**21-COA-0059**  
**2115 Frankfort Ave.**

**Clifton Architectural Review Committee**  
**Public Hearing**

**Bradley Fister, Historic Preservation Specialist**  
**October 20, 2021**

2115 Frankfort Avenue - Drive Thru Elevation  
Permit # COM-ALT-20-00535

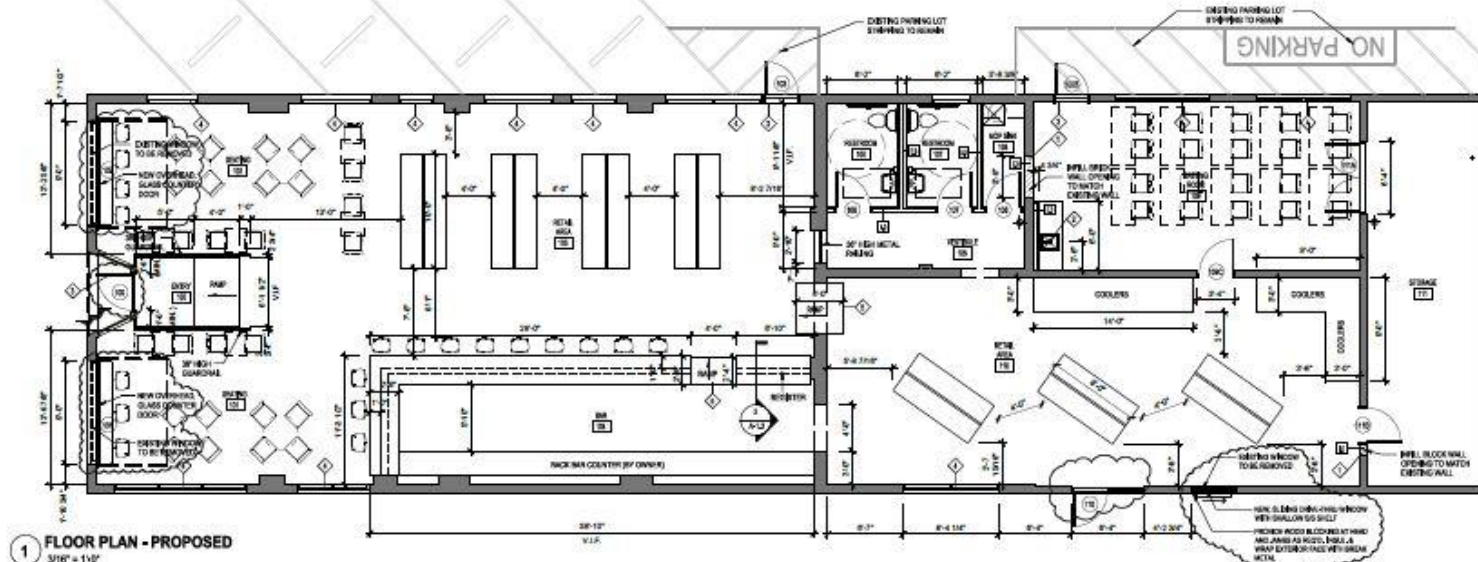
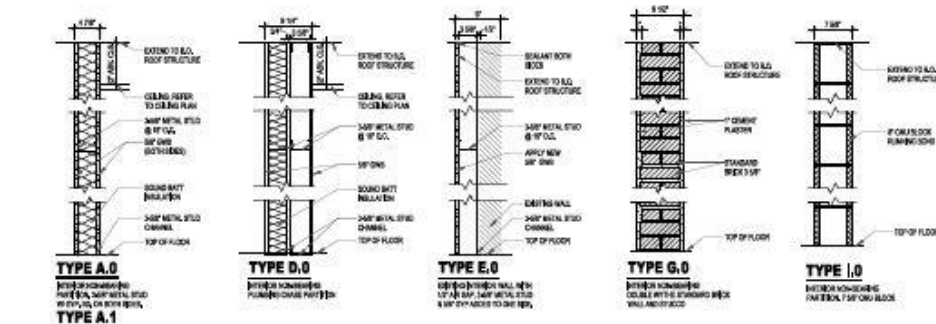
The proposed replacement of the side window, for a drive-thru window will be replacing a window that was previously replaced and is not on a primary elevation. The after- the-fact awnings generally meet the design guidelines, and help to break up the otherwise flat façade, while also providing a functional purpose to block a portion of the intense sunlight that washes over the building a large part of the day.
